工程指示 / 要求簡箋 ENGINEER INSTRUCTIONS (E.I.)

| 工程指示編號: | EI- 4790D | 修改版本: | D |
| 工程編號: | J 853 | 工程名稱: | 大窩坪 (延坪道) |
| 工程項目: | T3 幕牆單元件生產 (大貨) (修訂D:修改Z字碼設計及修改分格呎吋) | 日期: | 29/07/2022 |

| 名稱 | 生邊企 | 制圖 | 付吉寧 | 2022.05.20 | 修改 | A | B |

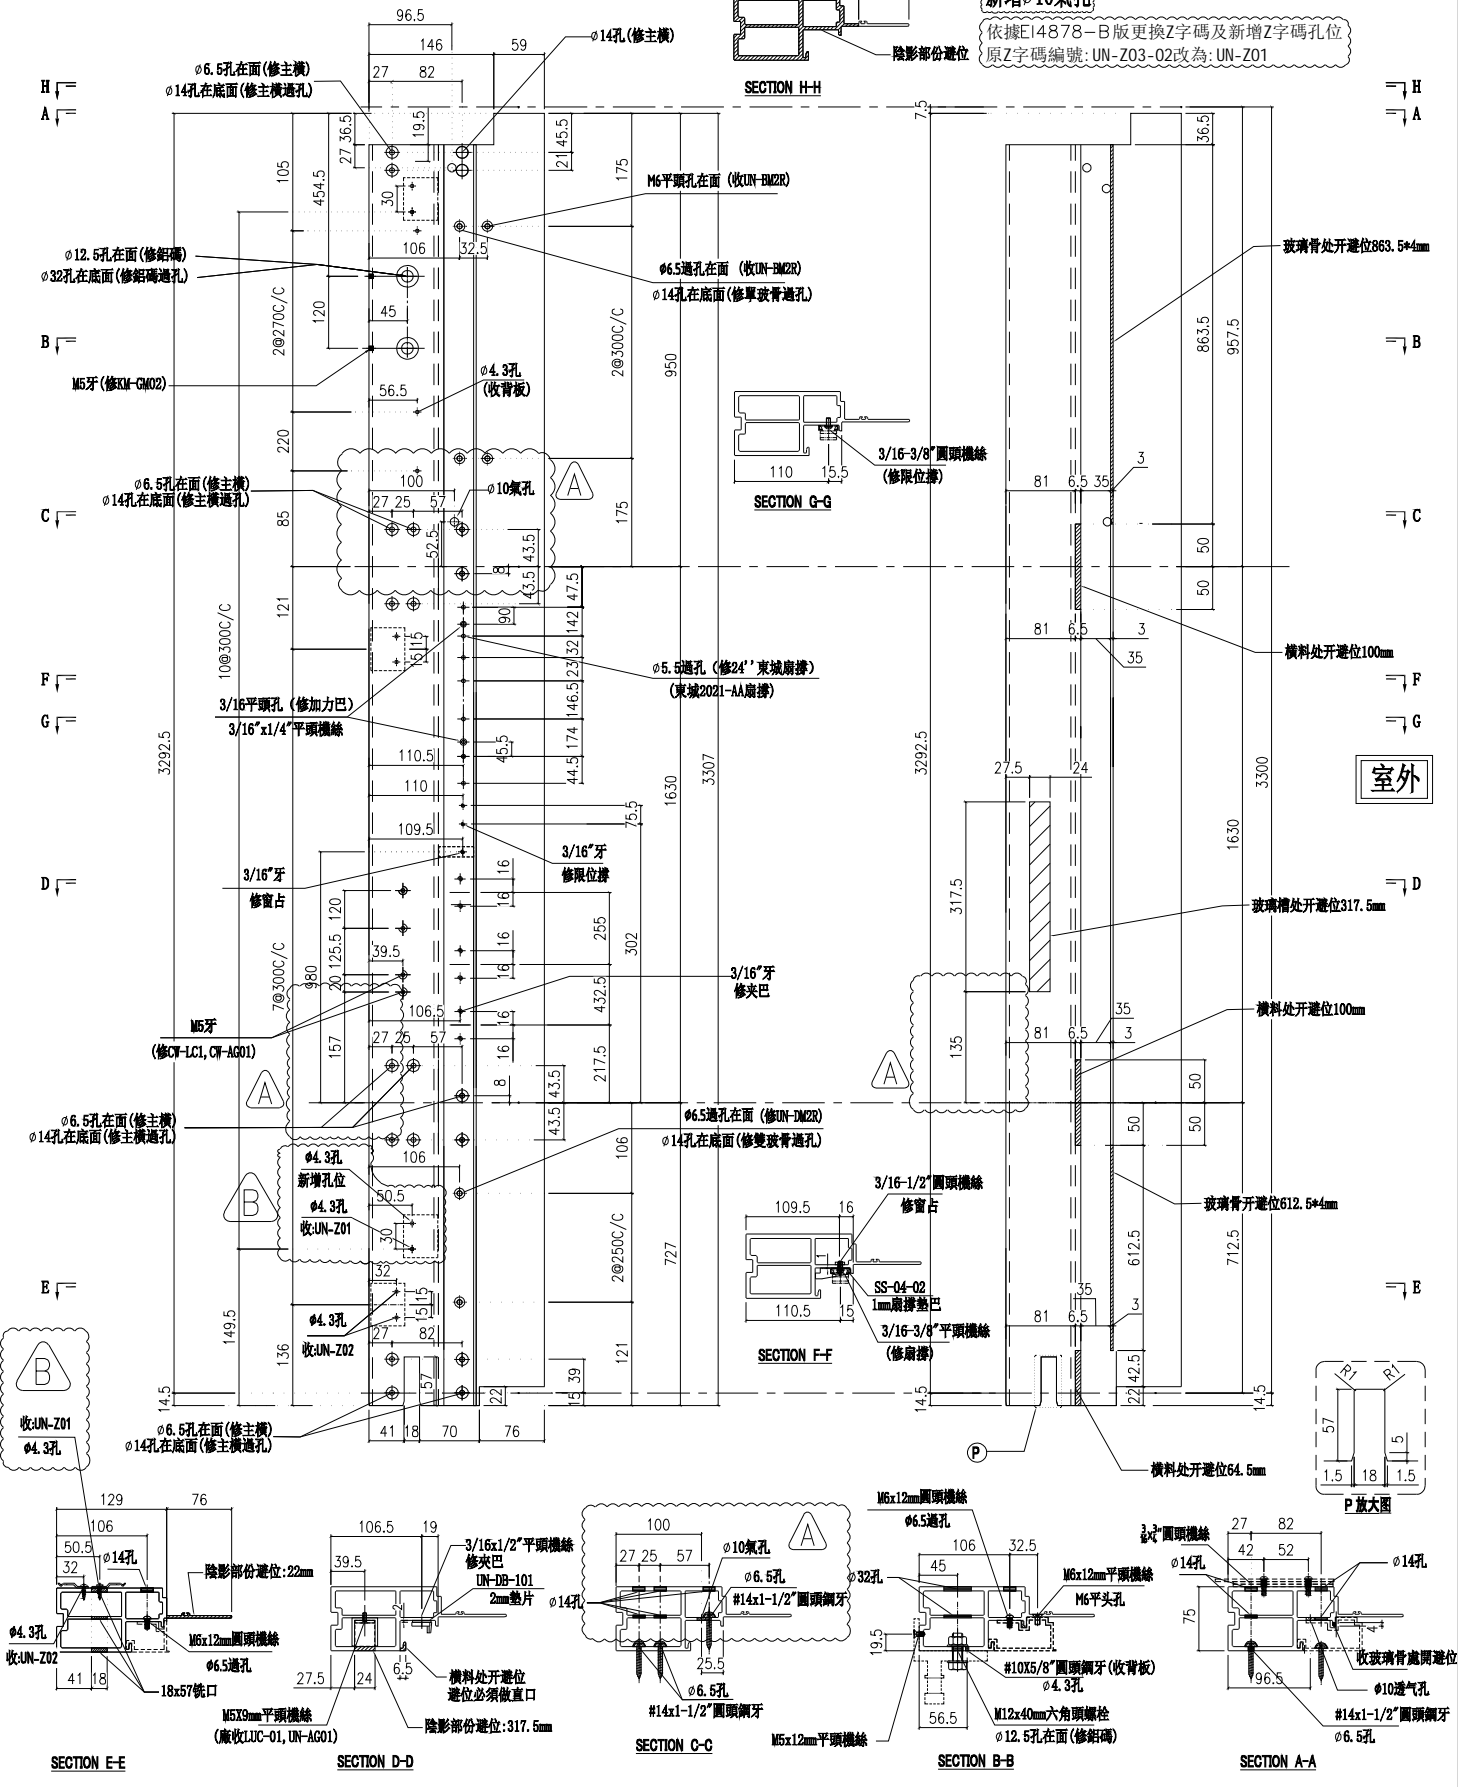
依據EI4825, 修改攔河槽及孔位尺寸

新增 $\phi 10$ 氣孔

依據EI4878-B版更換Z字碼及新增Z字碼孔位
原Z字碼編號: UN-Z03-02改為: UN-Z01

| 名稱 | 生邊企 | 制圖 | 付吉寧 | 2022.05.20 | 修改 | A | B |

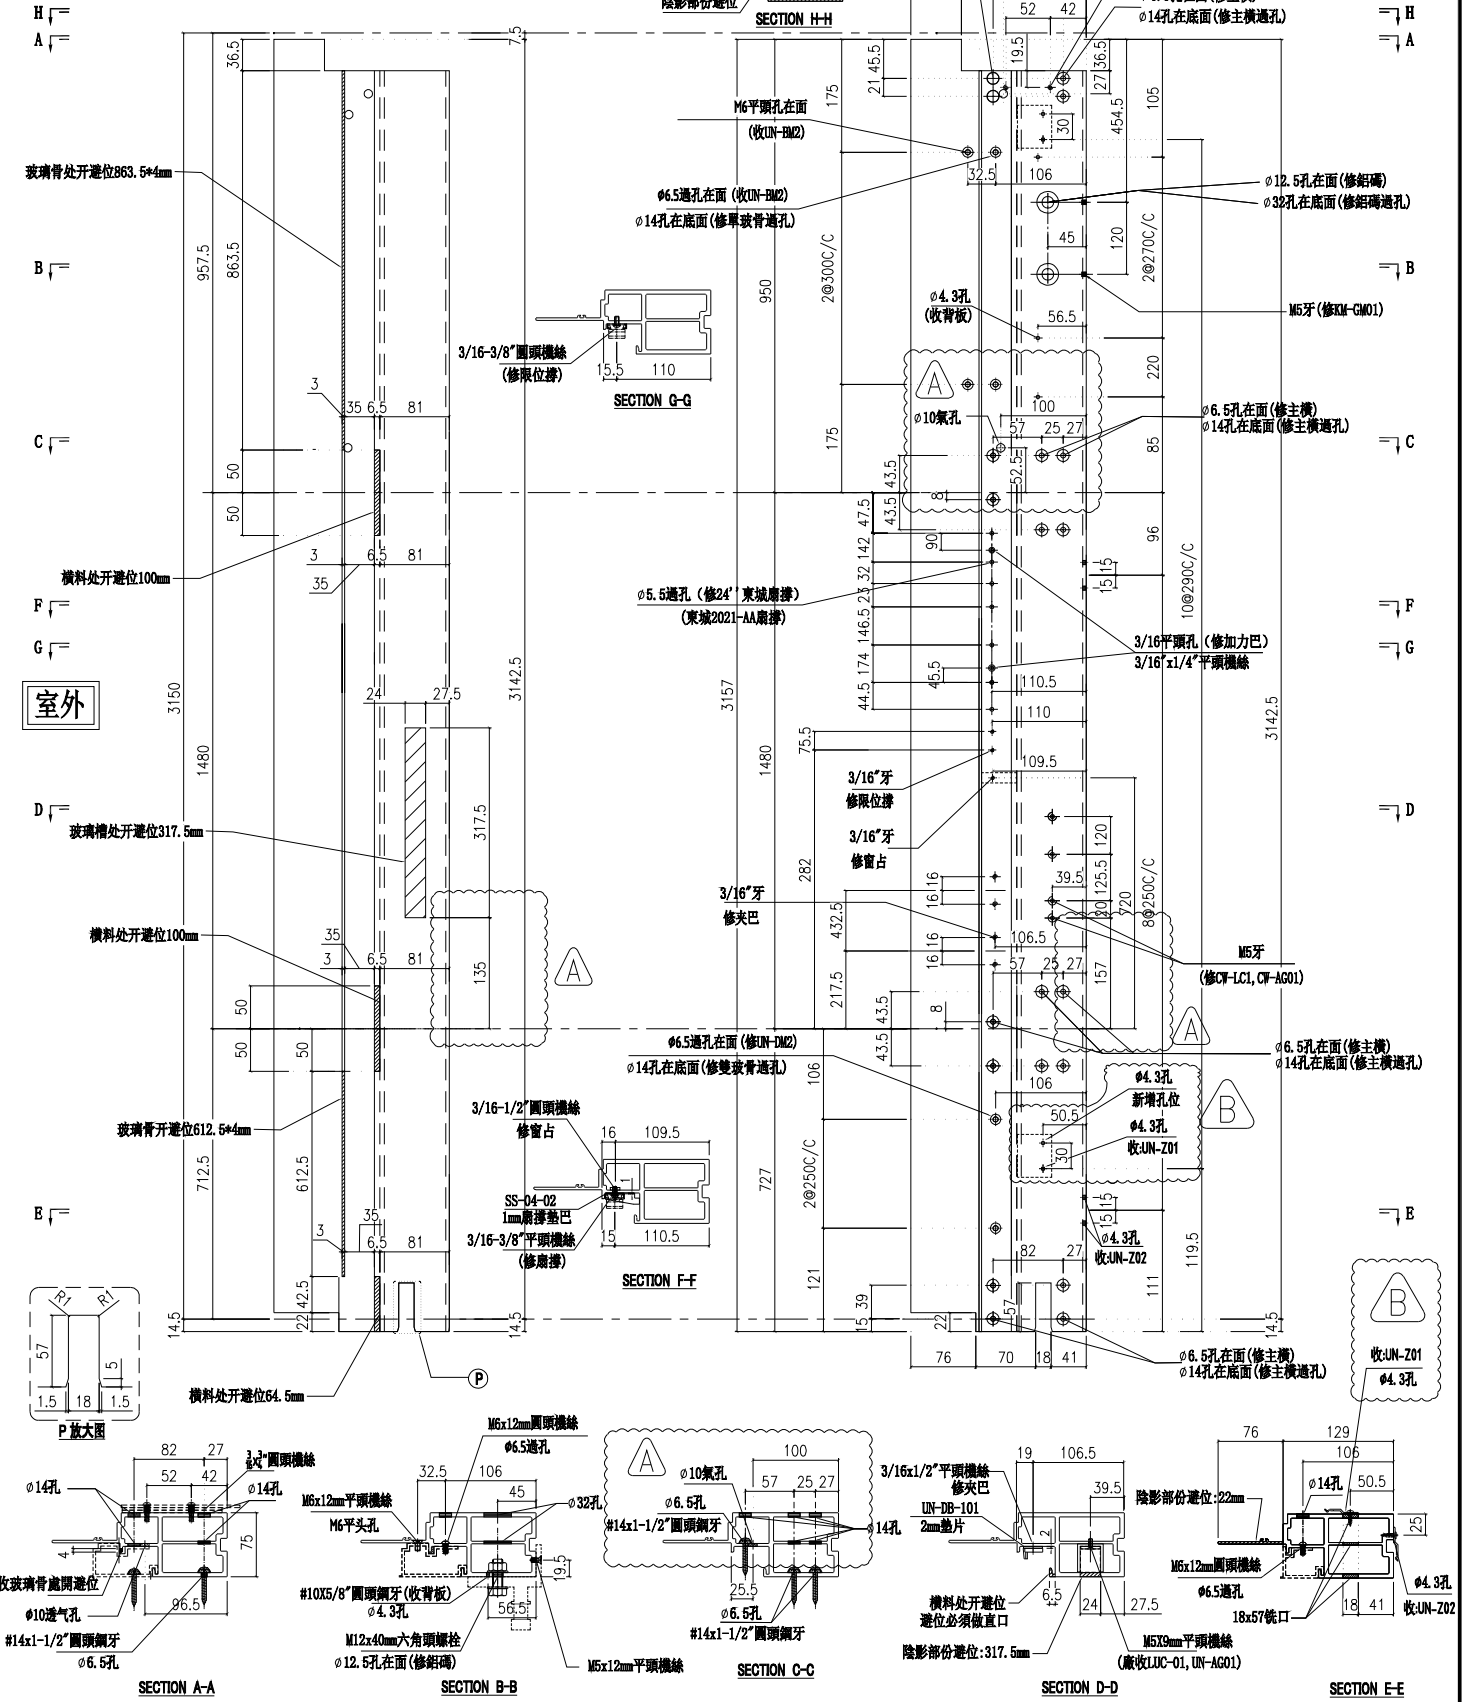
依據E14825, 修改欄河槽及孔位尺寸
新增 $\phi 10$ 氣孔
依據E14878-B版更換Z字碼及新增Z字碼孔位
原Z字碼編號: UN-Z03-01改為: UN-Z01

| 名稱 | 生邊企 | 制圖 | 付吉寧 | 2022.05.20 | 修改 | A | B |

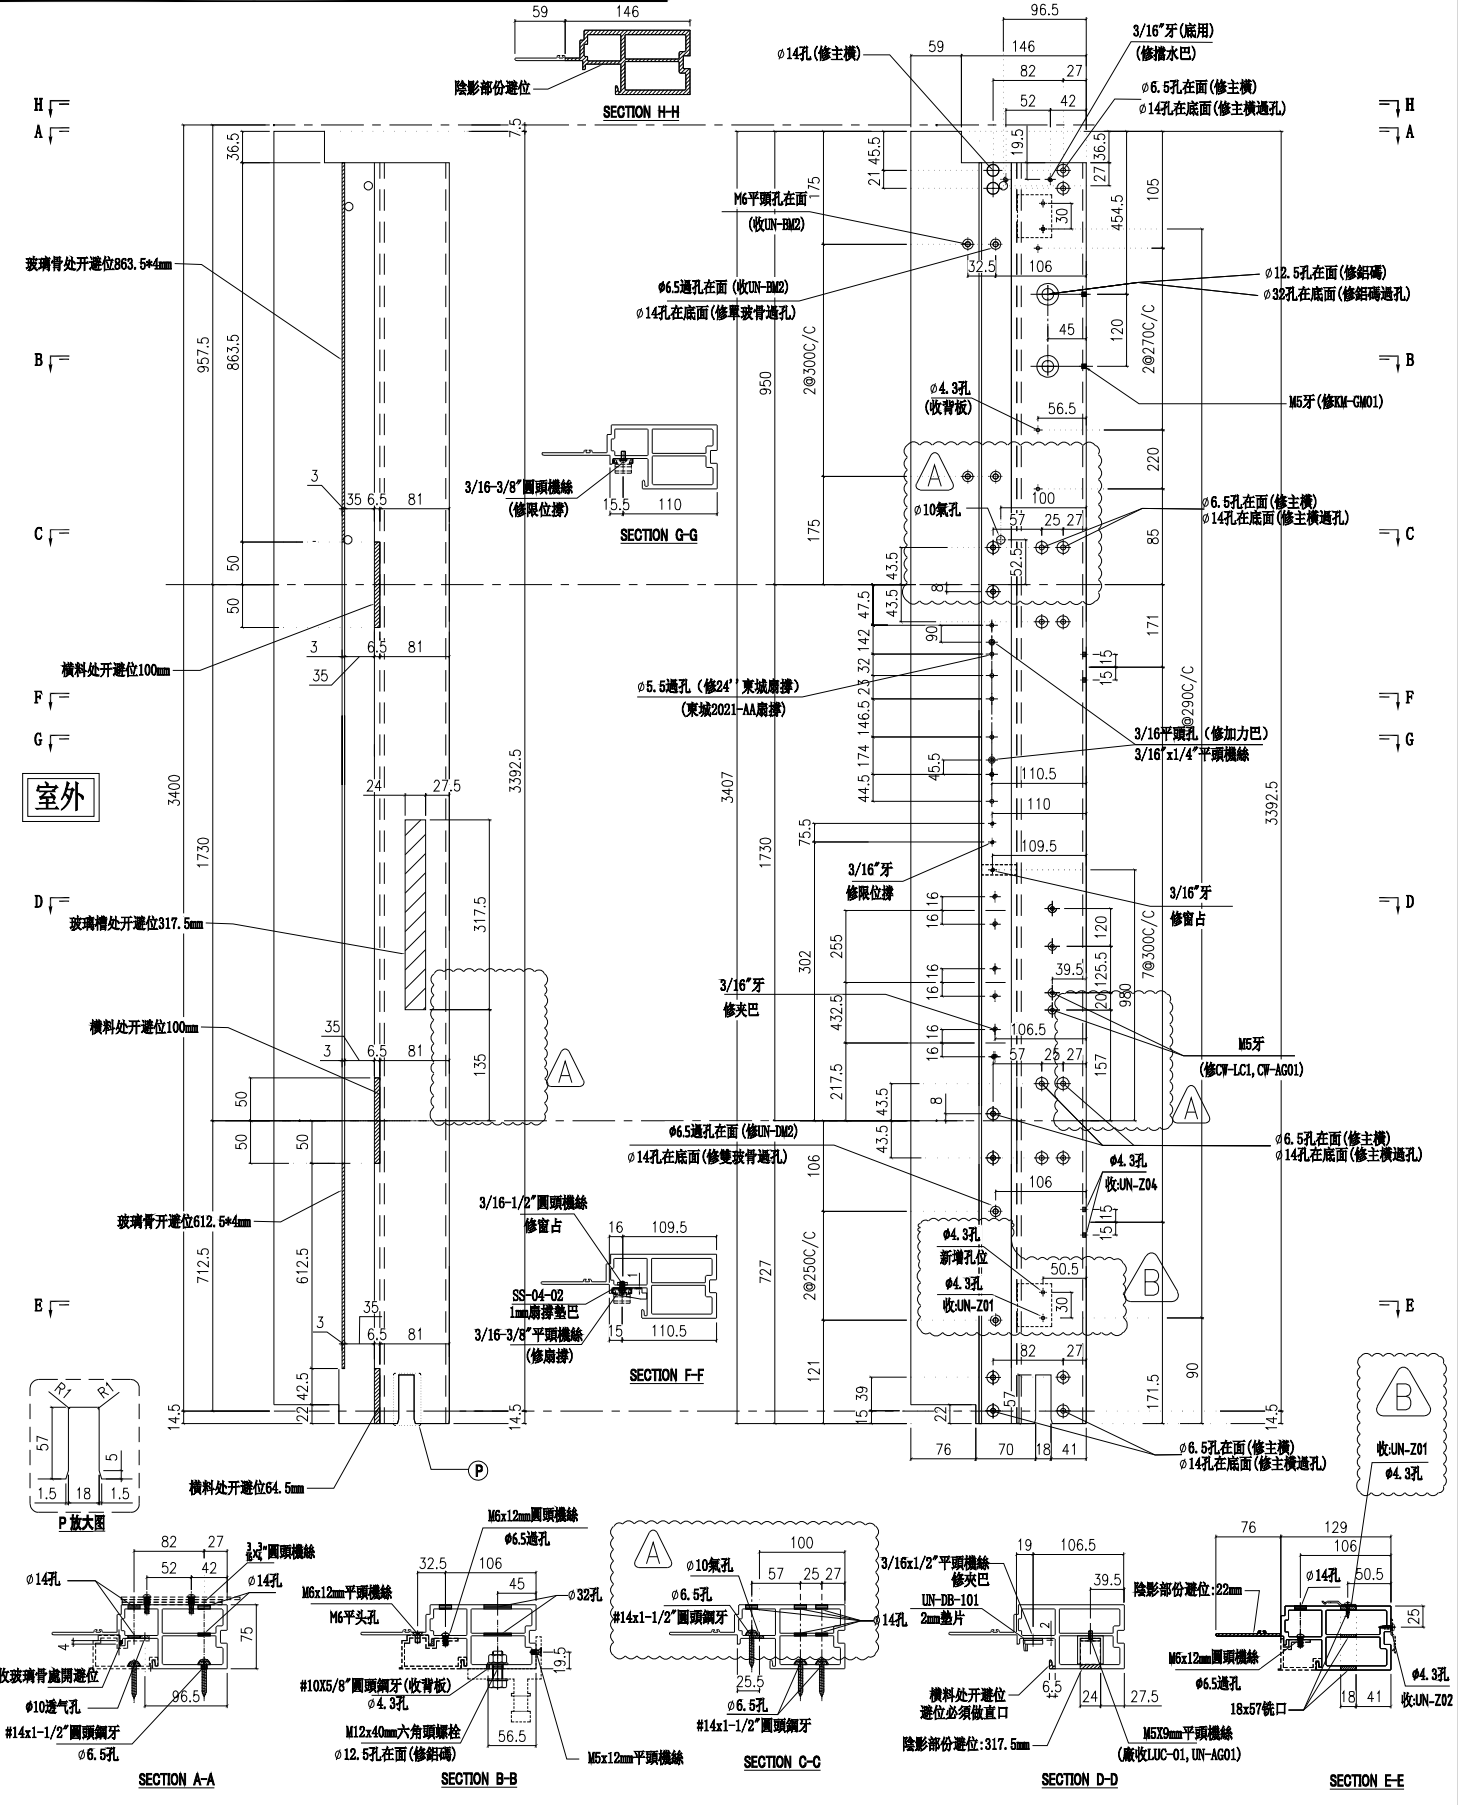
依據E14825, 修改欄槽及孔位尺寸
依據E14878-B版更換Z字碼及新增Z字碼孔位
新增 $\phi 10$ 氣孔
原Z字碼編號: UN-Z03-03改為: UN-Z01

| 名稱 | 生邊企 | 制圖 | 付吉寧 | 2022.05.20 | 修改 | A | B |

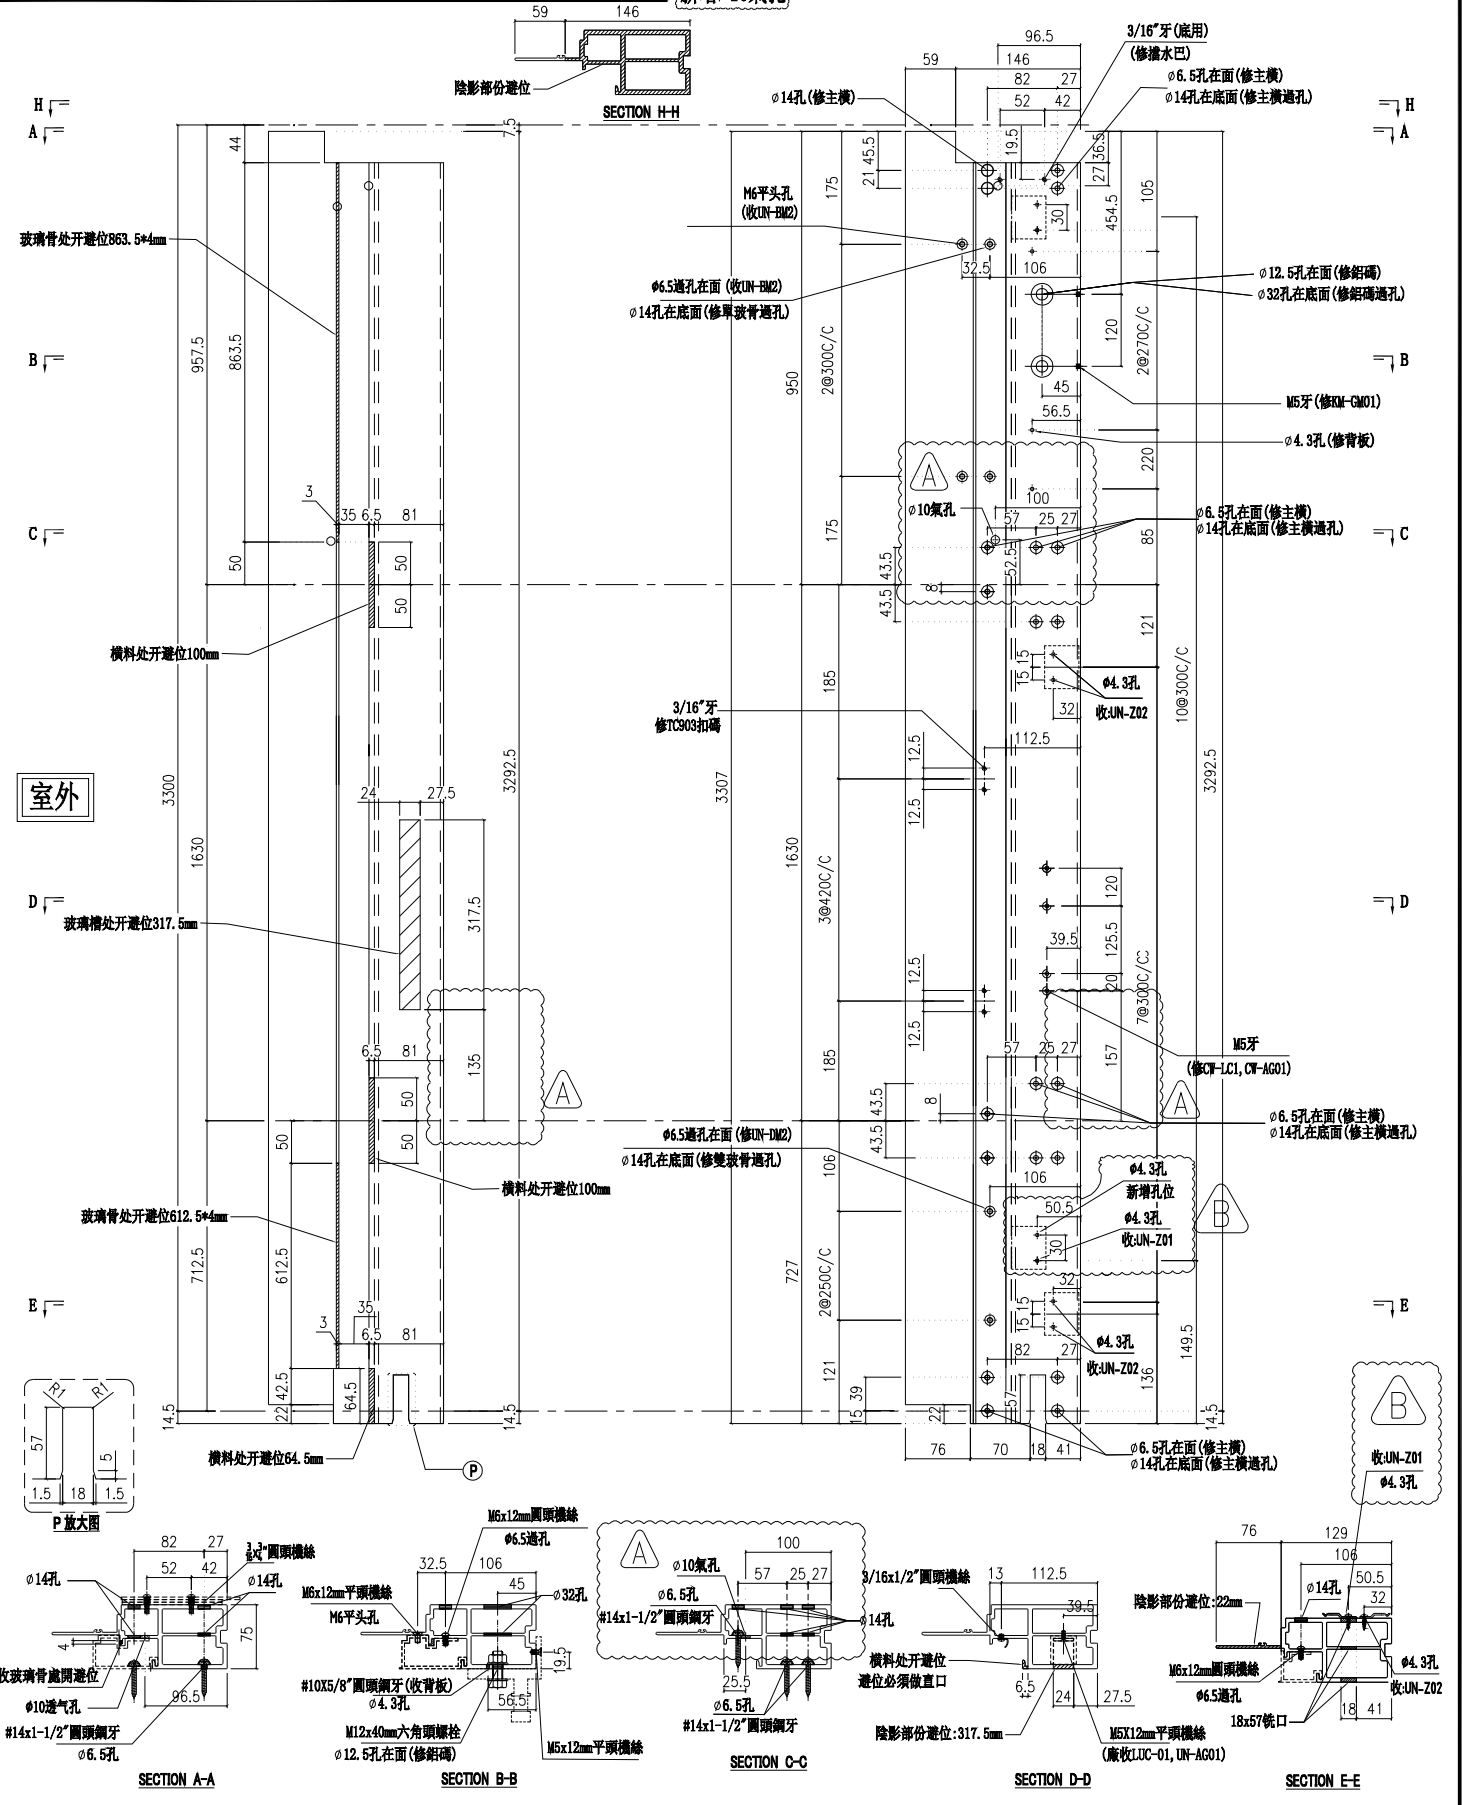
依據EI4825, 修改欄河槽及孔位尺寸
新增 $\phi 10$ 氣孔

依據E14878-B版更換Z字碼及新增Z字碼孔位
原Z字碼編號: UN-Z03-02改為: UN-Z01
